## GRU DNAPL Team Comments to EPA/Beazer Technology Assessment

USEPA Meeting of December 18-19, 2007

Prepared by Amy Callaway March 10, 2008

CHECKED	JRE	FIGURE: <b>5</b>
DRAFTED	KDO	
FILE	MC_TopContours.wor	
DATE	2/26/2008

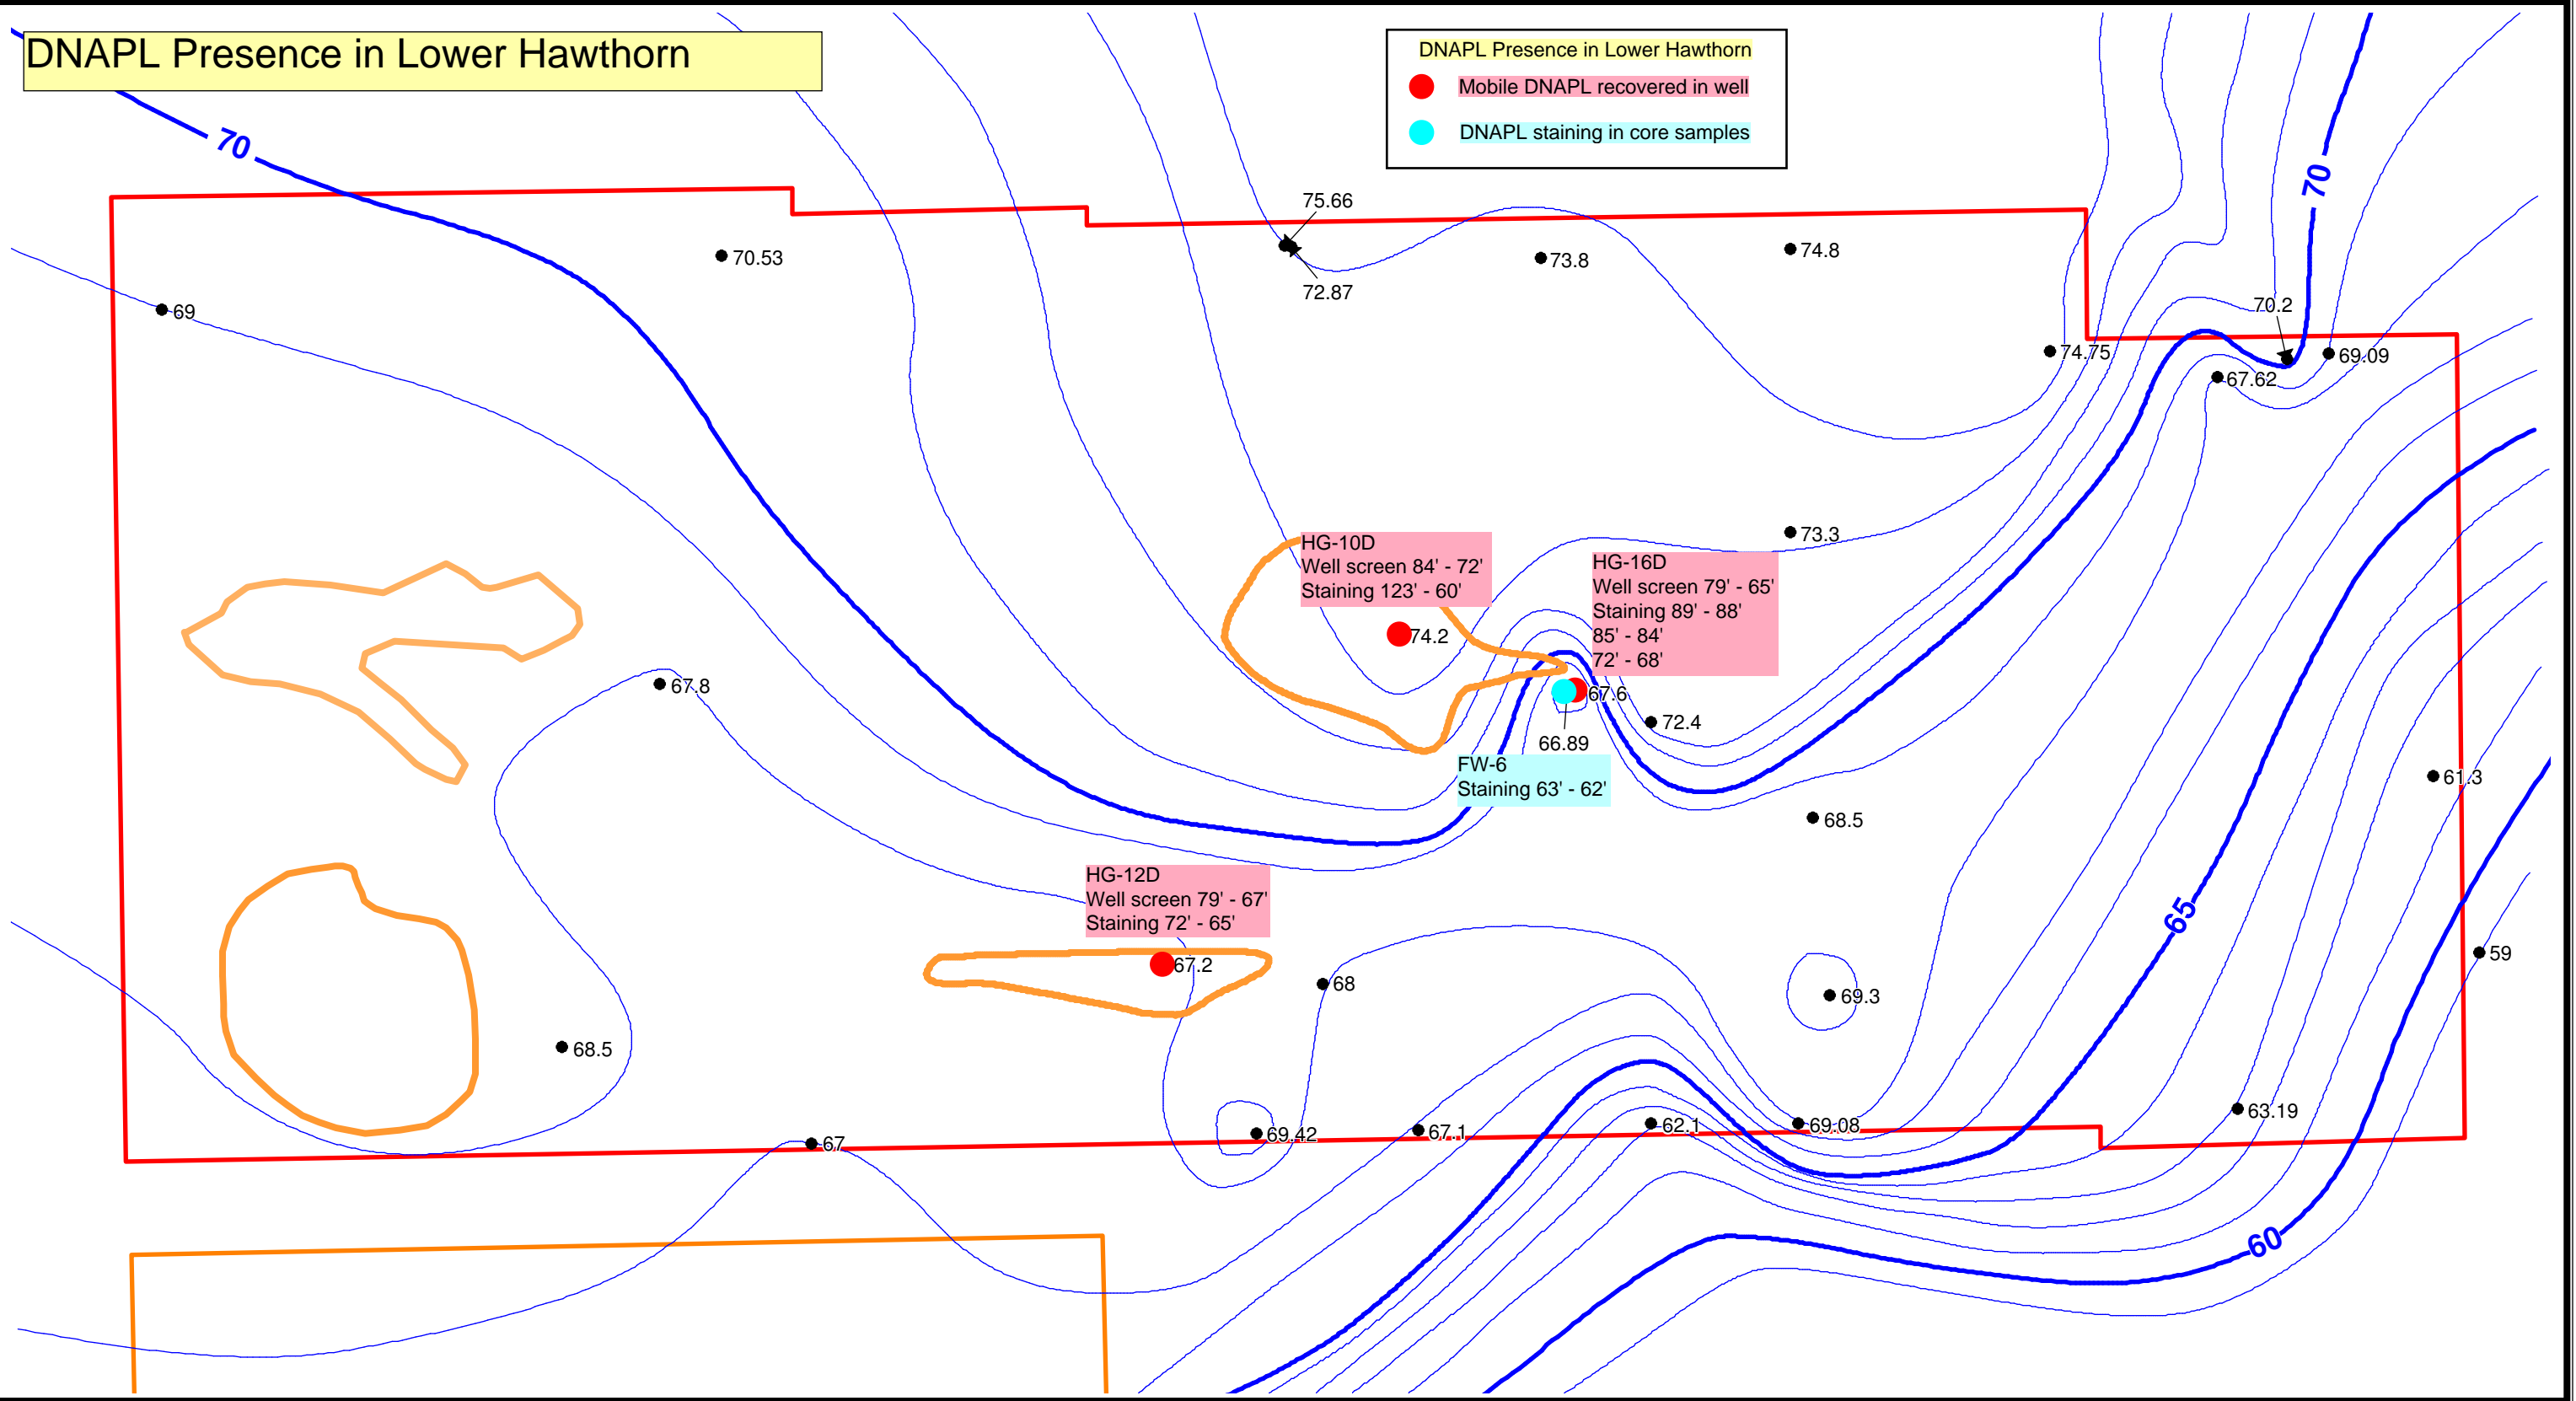
Alternative 4 assumes that in-situ solidification can trap the creosote DNAPL in place. We have modified maps of boring and well locations provided by GeoTrans and provided them as attachments to this document, to show where evidence of DNAPL was observed. EPA and Beazer should clarify where in-situ soil solidification will be implemented. That comment applies to all remedial alternatives for the Surficial and the Hawthorn. Secondly, we strongly suspect that the creosote DNAPL has migrated offsite and to the east of the railroad tracks, therefore certain areas might not be amenable to such treatment. Do EPA and Beazer intend to implement in-situ solidification offsite?

# DNAPL Presence in Upper Hawthorn

**DNAPL Presence in Upper Hawthorn**  
 ● Mobile DNAPL recovered in well

CHECKED	JRE	FIGURE: <b>2</b>
DRAFTED	KDO	
FILE	UC_TopContours.wor	
DATE	2/26/2008

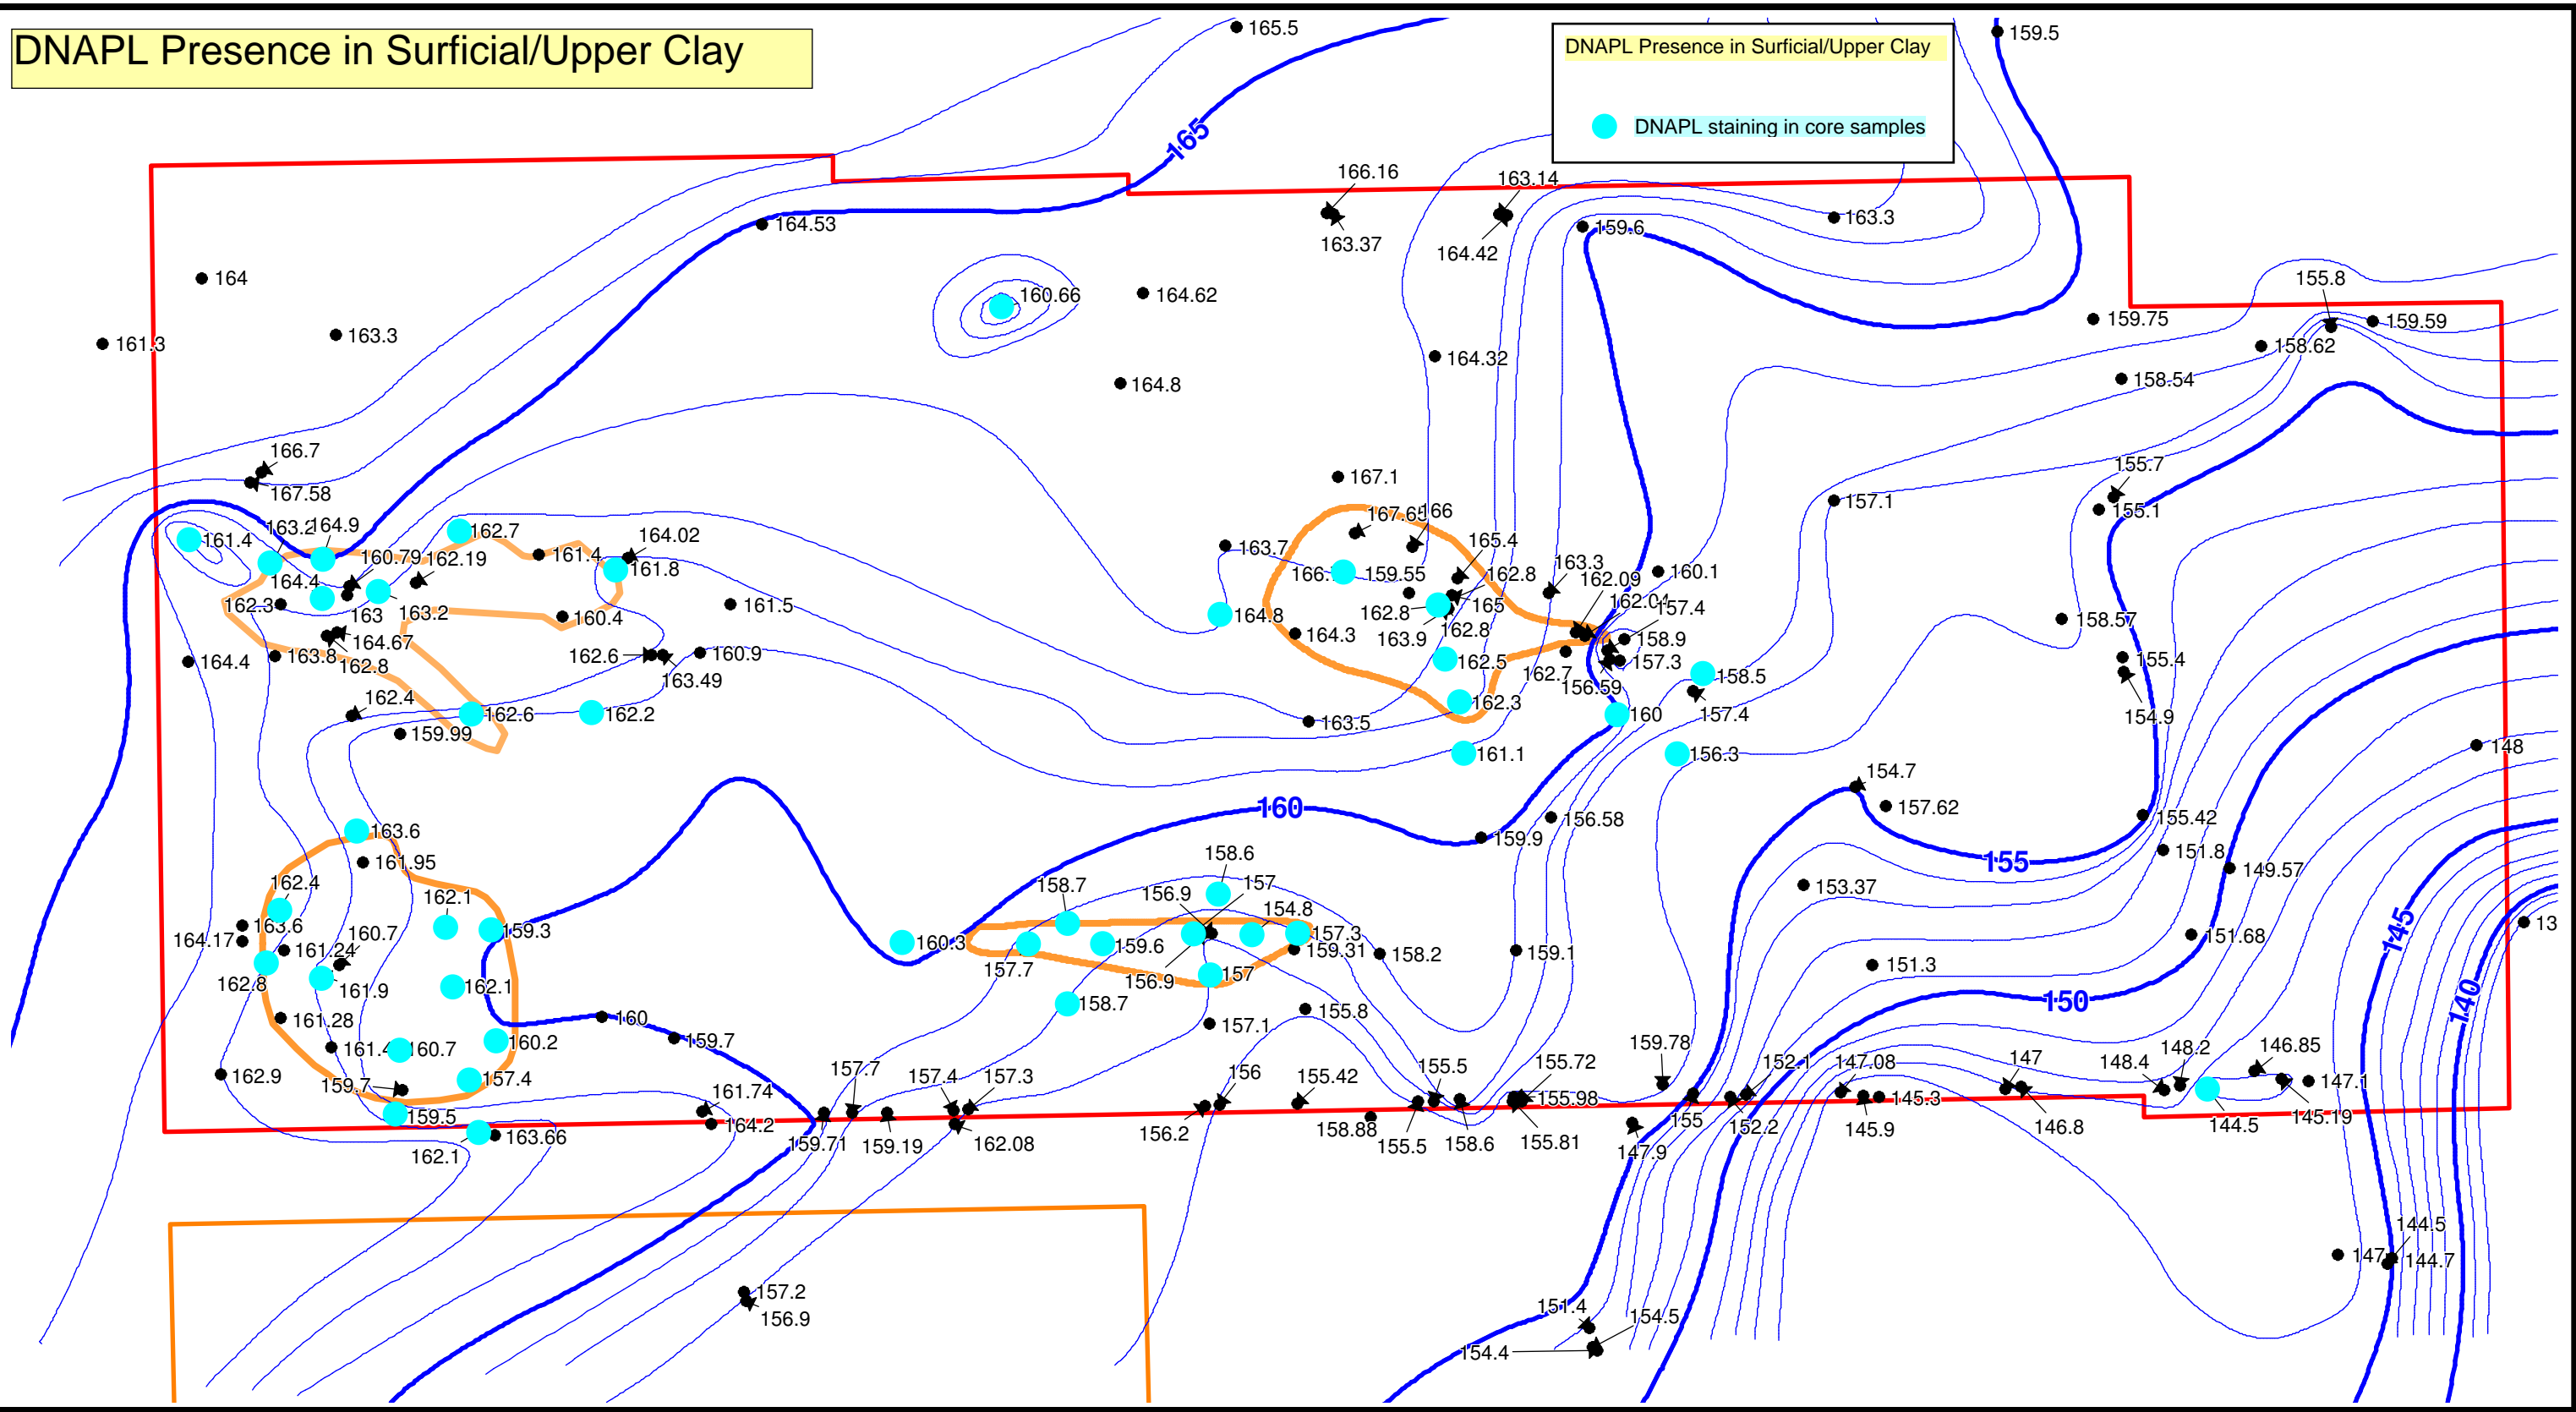
# DNAPL Presence in Surficial/Upper Clay

DNAPL Presence in Surficial/Upper Clay

● DNAPL staining in core samples
